ALERT SERVICE BULLETIN

212-20-163

MODEL AFFECTED: 212

SUBJECT: ENGINE OIL CHECK VALVE P/N 209-062-520-001,
INSPECTION AND REPLACEMENT OF.

Figure 1. Engine Oil Check Valves Locations

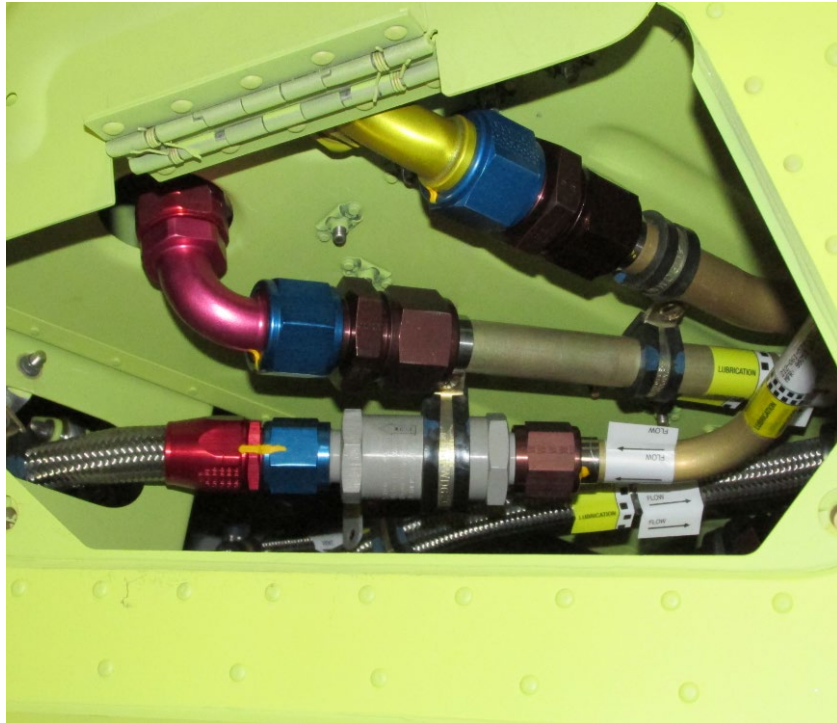
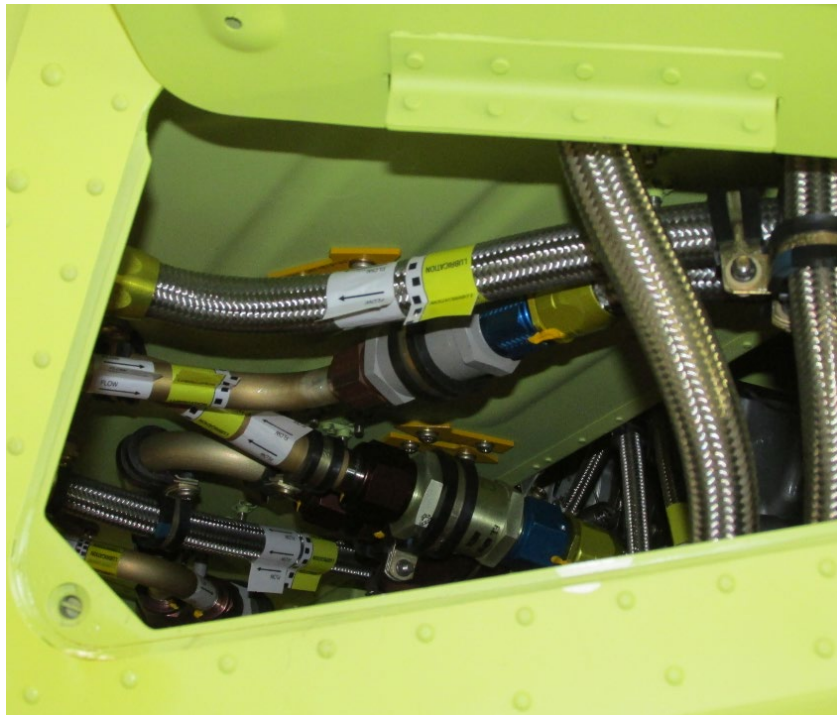
1. Prepare the helicopter for maintenance and gain access to the engine oil check valves. The engine oil check valves are located in the engine reduction gearbox compartment under the oil coolers (Figure 1, Details A and B).

Figure 3. Engine Oil Check Valve Outside Diameter Measurement

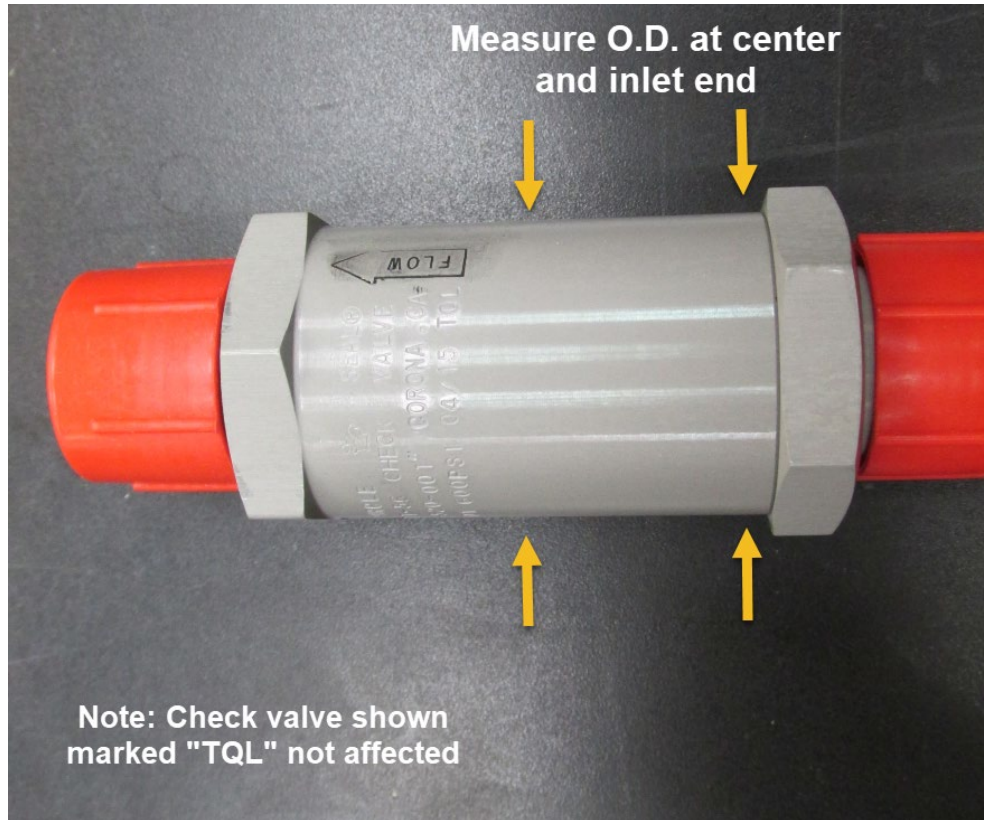
- d. If the dimension measured at the inlet end is greater than 0.003 inch (0.0762 mm) when compared to the measurement at the center, the valve will require replacement. Part III can be accomplished immediately, or Part II can be accomplished until the defective valve can be replaced in accordance with Part III.
- e. If the defective check valve is not replaced immediately, make an entry in the helicopter logbook and historical service records indicating the findings and that Part II must be accomplished every 25 flight hours or 30 days whichever comes first until Part III is accomplished.

1. Prepare the helicopter for maintenance and gain access to the engine oil check valves (Figure 1, Details A and B).
2. Using a strong light source, visually inspect the oil check valves for general condition and oil leaks. Inspect for cracks at the inlet end where the threaded fitting is installed (Figure 3).
3. If a crack is found, replace the check valve prior to next flight. Figure 4 shows an example of a cracked check valve.
4. If no cracks or any other defects that would cause the valve to be unserviceable are found, make an entry in the helicopter logbook and historical service records indicating the findings and that Part II will require accomplishment until Part III is accomplished.

Figure 4. Cracked Engine Oil Check Valve

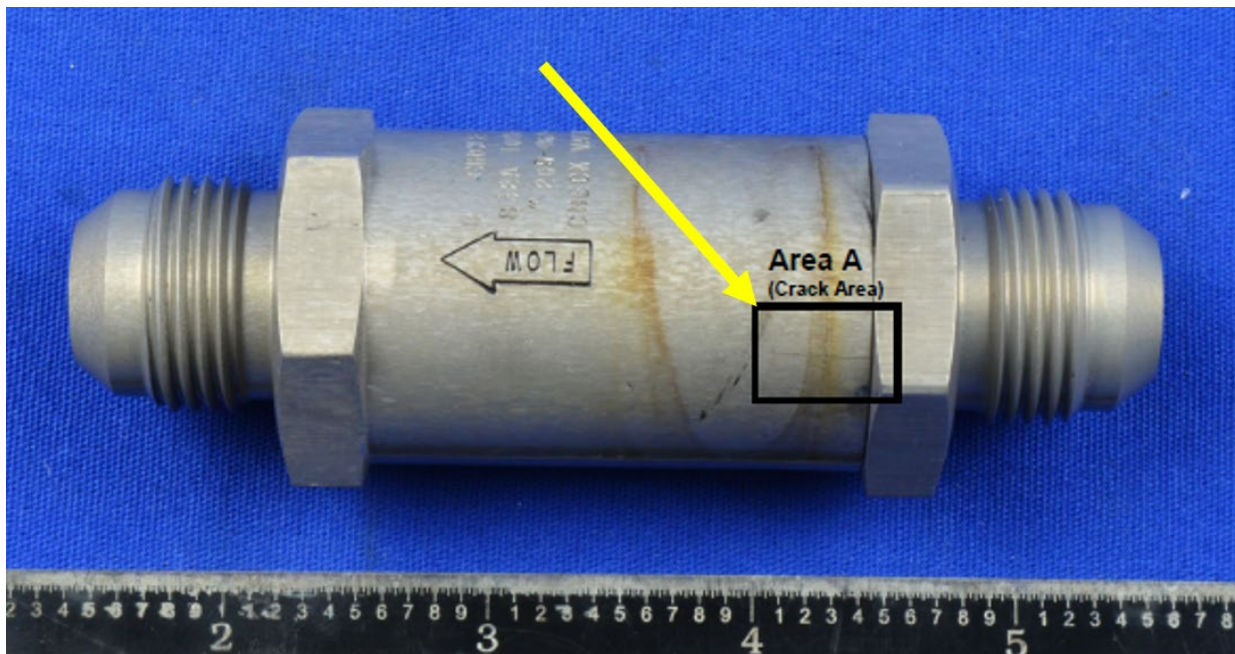
Bell recently received a report of a cracked check valve manufactured by Circor Aerospace (Circle Seal). This check valve was manufactured in 2009 which is outside of the manufacturing date range (October 2011 – March 2015) addressed by the ASB 212-15-153 Rev A. Corrective actions implemented in 2015 by Circor Aerospace to prevent cracking of the check valve housings are indicated by the "TQL" marking.

This recent check valve cracking report indicates that additional oil check valves P/N 209-062-520-001 manufactured by Circor Aerospace (Circle Seal) not having the “TQL” marking may be susceptible to cracking with time in service.
